DTC Modification

306 Gay St 2018DTC-003-001 19 – O'Connell

Item # 1

Ground Floor Height

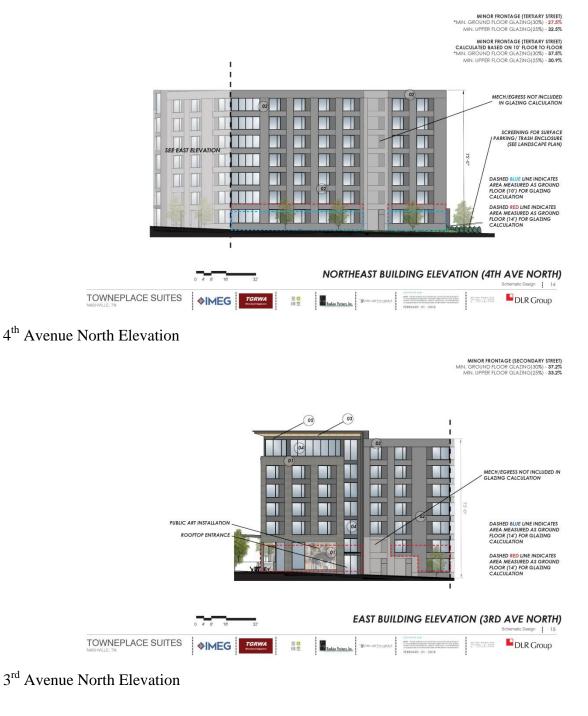
The DTC requires 14 foot minimum ground floor height and the applicant is proposing 10 feet along 4th Avenue North and a portion of 3rd Avenue North. 3rd Avenue North is a Secondary street and 4th Avenue North is a Tertiary street and both are considered minor frontages. Though an active use is not required along Tertiary streets, the applicant is proposing to activate the street with hotel rooms. The intent of the 14 foot ground floor height standard is to accommodate retail, restaurant and lobby uses, but would not be necessary for the proposed hotel room use. Along Gay Street, which is the primary frontage with the lobby and retail use, the building is meeting the 14 minimum ground floor height standard.
